November 1968

IGNITION SWITCHES - 1968 12HP TRACTORS

SWITCH No. 7572
(MAGNETO TYPE)

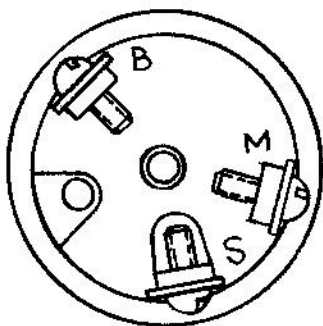
Later models of the 1-6231 (Raider 12) and 1-7231 (Charger 12), as outlined in Wheel Horse Service Bulletin #93, incorporate the K 301S-47147B Kohler engine equipped with BENDIX TYPE STARTER, and ALTERNATOR charging system with MAGNETO IGNITION. These units require MAGNETO ignition switches.

Switch #7572 is a "MAGNETO TYPE" switch and can be identified by "B", "M", AND "S" terminals. See Drawing

SWITCH No. 7263
(BATTERY TYPE)

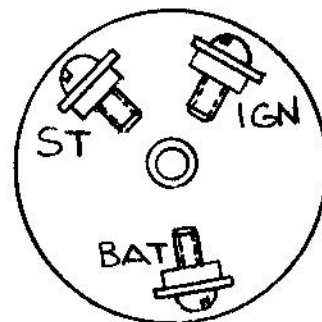
As covered in Wheel Horse Service Bulletin #93 early model 1-6231 (Raider 12) and 1-7231 (Charger 12) tractors incorporate the model K 301S-4712B Kohler engine equipped with Starter-Generator units. These units are equipped with BATTERY IGNITION and require BATTERY ignition switches.

Switch #7263 is a "BATTERY TYPE" switch and can be identified by the "BAT", "ST", AND "IGN" terminals. See Drawing

To avoid possible damage to ignition system components and/or charging system components it is imperative that the correct replacement switch be used. THE PARTS LIST DESIGNATES ONLY THE SWITCH FOR THE LATE ENGINES.
